Design Standards
and Guidelines
Errata

April 09, 2021

ERRATA

This Errata is an attachment to the [Downtown West Design Standards and Guidelines \(DWDSG\) issued on March 1, 2021](#). Together the Errata and DWDSG comprise a full and complete record of the vision, requirements, and recommendations for new development within the Downtown West Mixed-Use Plan.

FIGURE 5.9: Block plan

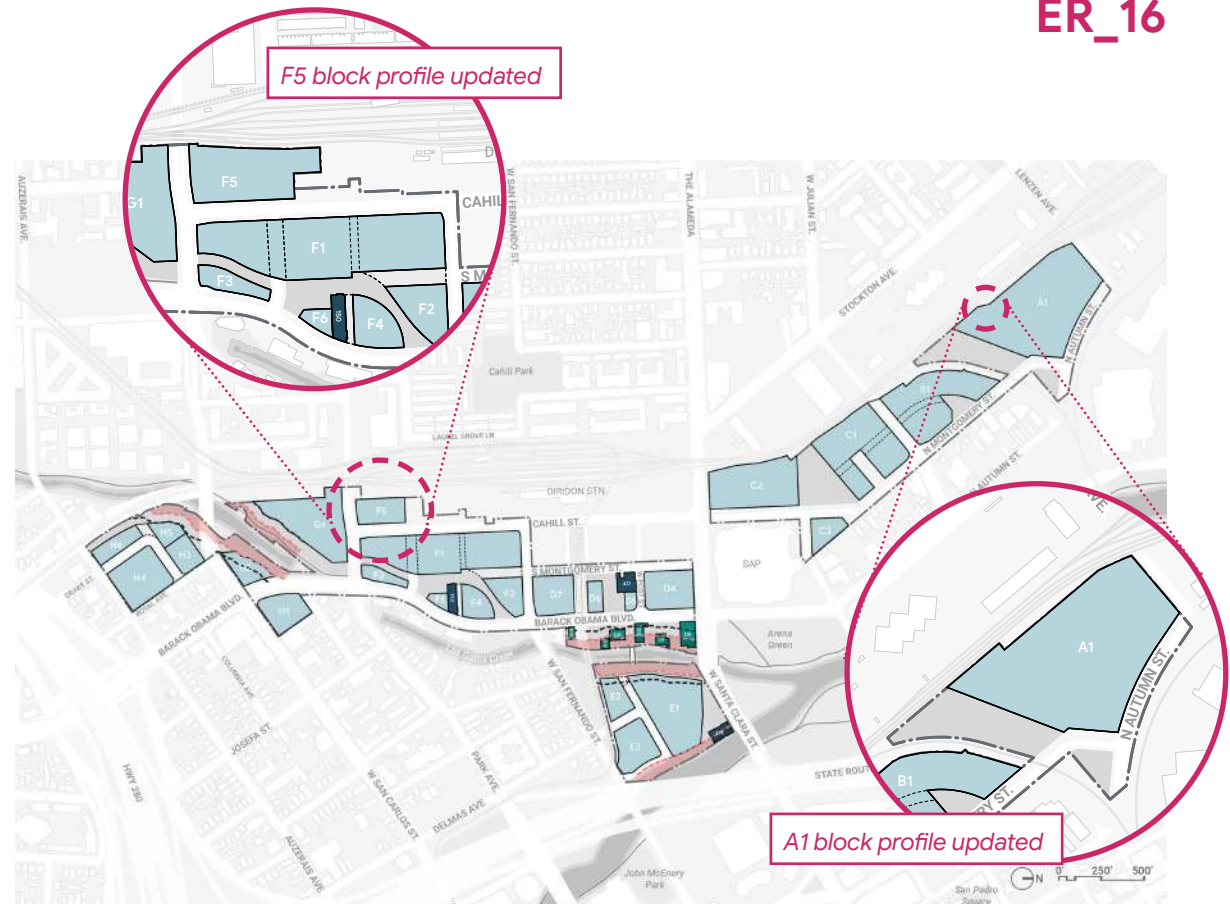
ER_14	170	Buildings	Figure 5.7	Addition of long facade demarcation on F5 east (secondary) and F5 west (primary).
ER_15	171	Buildings	Table 5.1	Addition of long facade demarcation on F5
ER_16	173	Buildings	Figure 5.9	Site boundary changes at F5 and A1
ER_17	176	Buildings	S5.5.7	<p>“ • The existing structure at block D13 shall be replaced by the relocated 35 South Autumn Street (Barack Obama Boulevard) main structure (see S5.15.3). The structure from 35 South Autumn Street shall be relocated within the building footprint of 74 South Autumn (Barack Obama Boulevard) and outside of the 50-foot Los Gatos Creek Riparian Setback.</p> <p>• If the property owner elects to demolish any building on blocks D9 or D12-D12-or-D13, the property owner is permitted to replace the demolished built area in a new building elsewhere in Creekside Walk. Replacement structures for blocks D9 or D12-D12-and-D13 shall not encroach into the 50-foot Los Gatos Creek Riparian Setback. Individual replacement structures shall be permitted to exceed the gross square footage of the existing structure in accordance with the square footage limits of additions described below. Replacement structures are subject to applicable standards in Sections 5.6, 5.7, 5.8, and 5.13.”</p>

FIGURE 5.11: FAA NAVD 88 maximum height contours

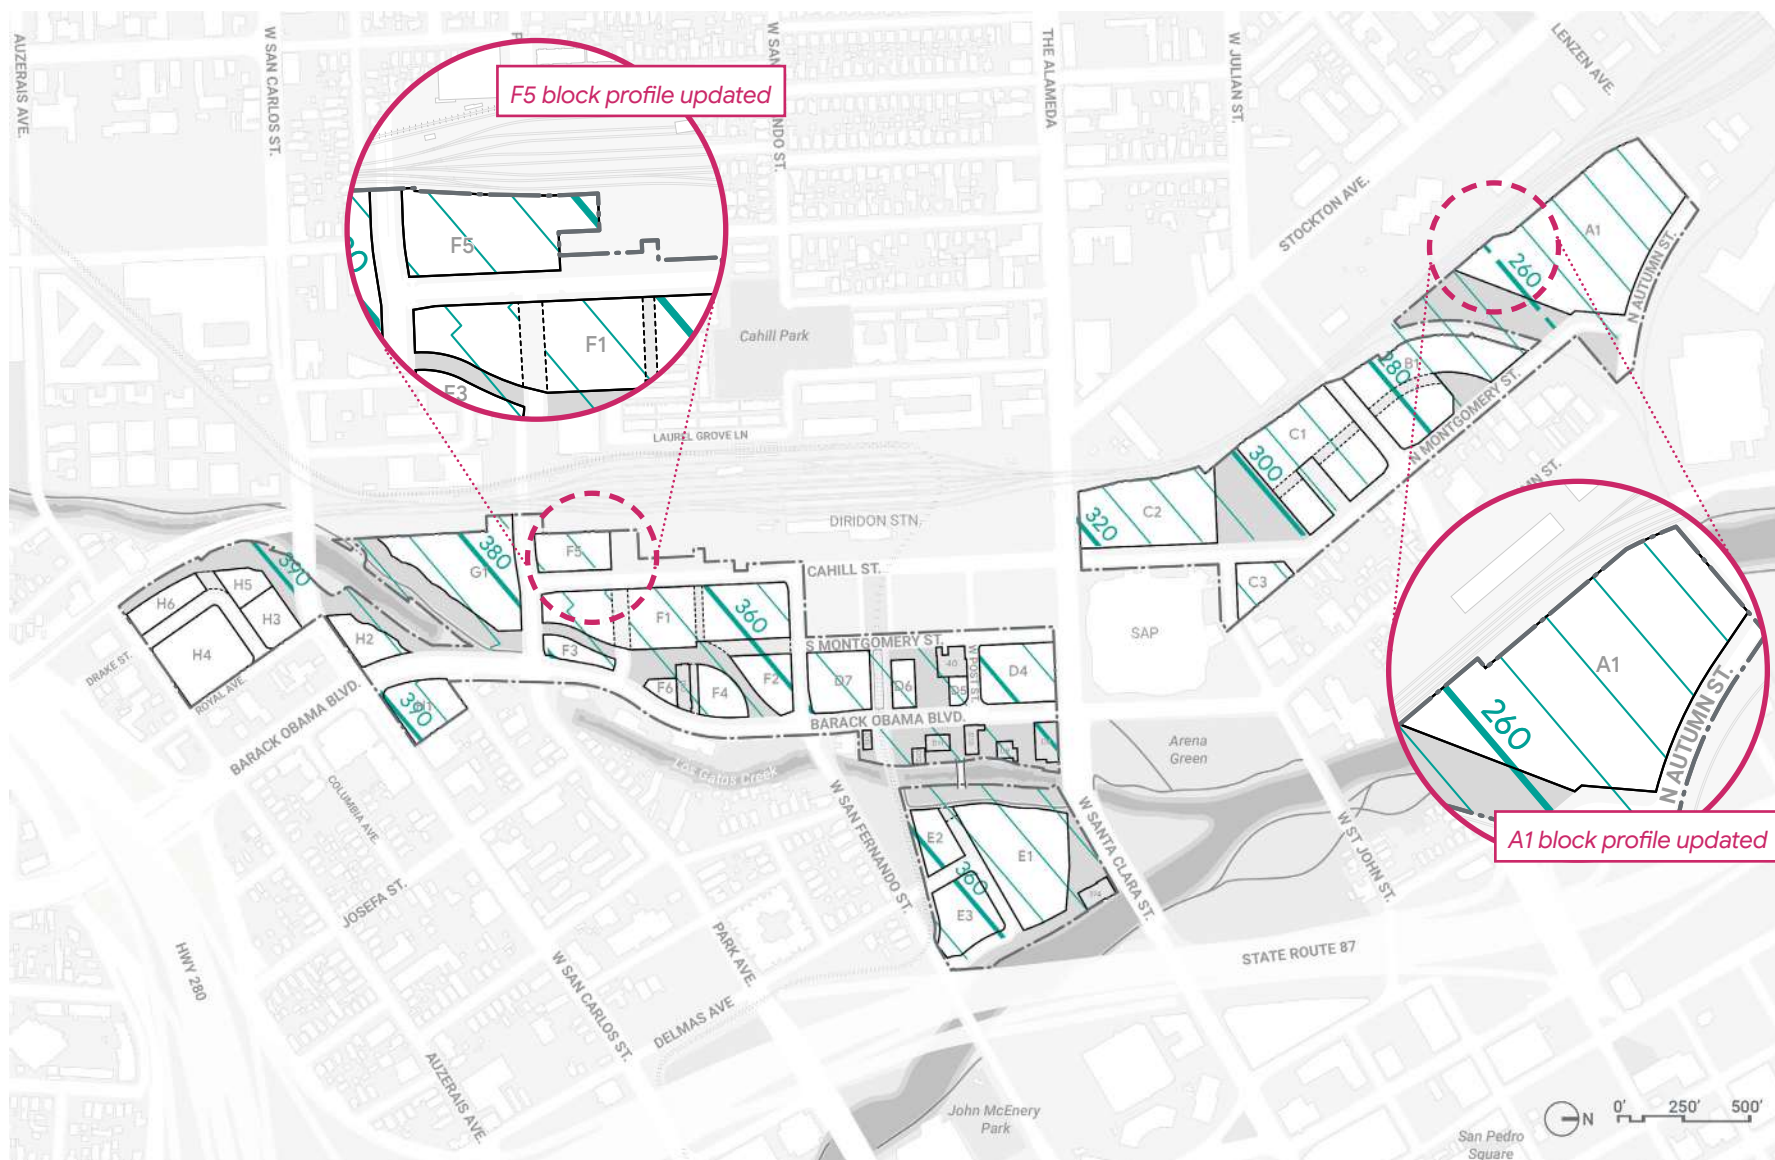
ER_18	178	Buildings	Figure 5.11	Site boundary changes at F5 and A1
ER_19a	179	Buildings	S5.6.3	“.... Additional perimeter height and massing requirements apply to blocks E1/G1 (S5.17.2), E2/E3 (S5.15.15 and S5.15.16), H1 (S5.16.2), H2 (S5.17.1), and H3/H4/H6 (S5.16.3). Height and footprint limits to structures within open space outside of new development blocks, identified in Figure 5.9, are outlined in Section 4.25.”
ER_19b	179	Buildings	Figure 5.12	Site boundary changes at F5 and A1
ER_20	180	Buildings	Figure 5.13	Site boundary changes at F5 and A1

FIGURE 6.53: Conceptual off-street parking garages

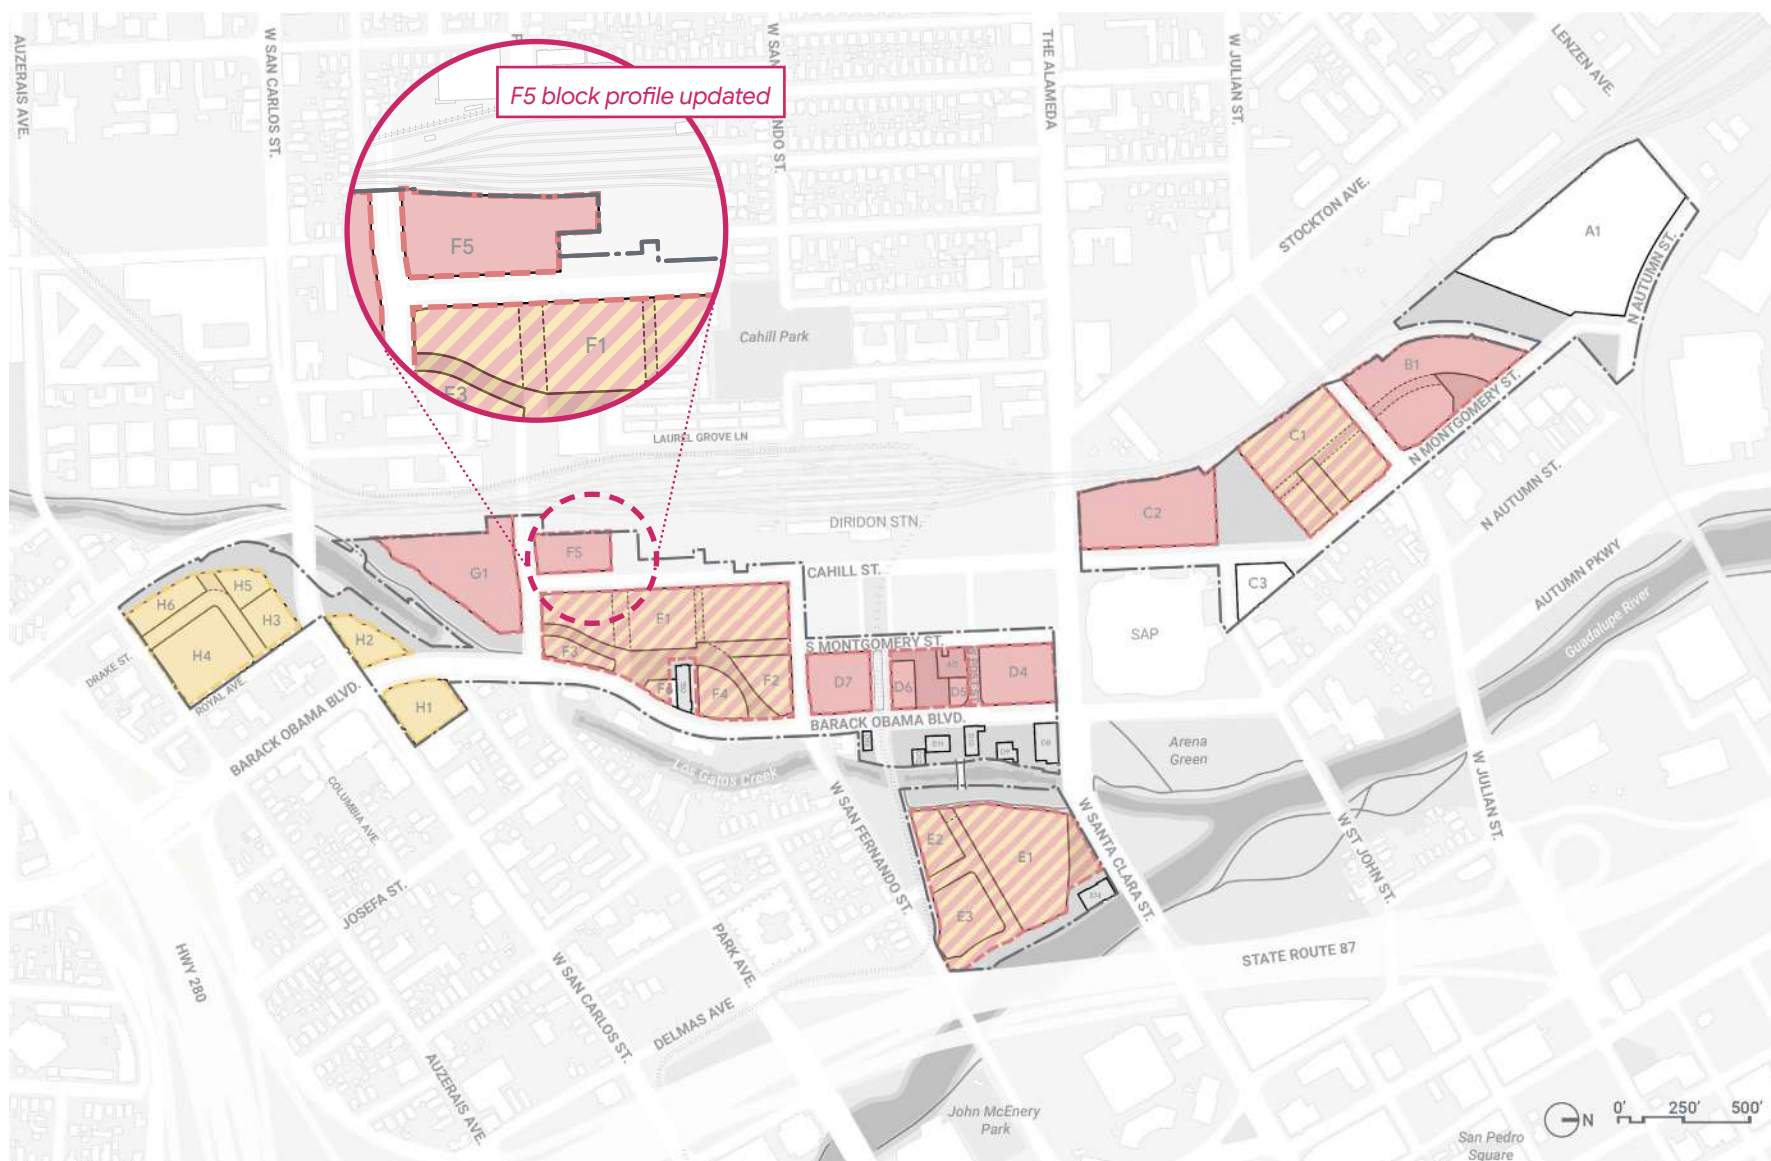
ER_28	297	Mobility	Figure 6.53	Site boundary changes at F5 and A1
ER_29	299	Mobility	Figure 6.54	Site boundary changes at F5 and A1
ER_30	307	Lighting and Signage	S7.3.3	“All open space lighting, excluding lighting for art, shall install lighting that has have a color temperature of less than or equal to 2,700 2700 kelvins. Lighting requirements for art adjacent to a riparian corridor shall follow S7.4.7.”
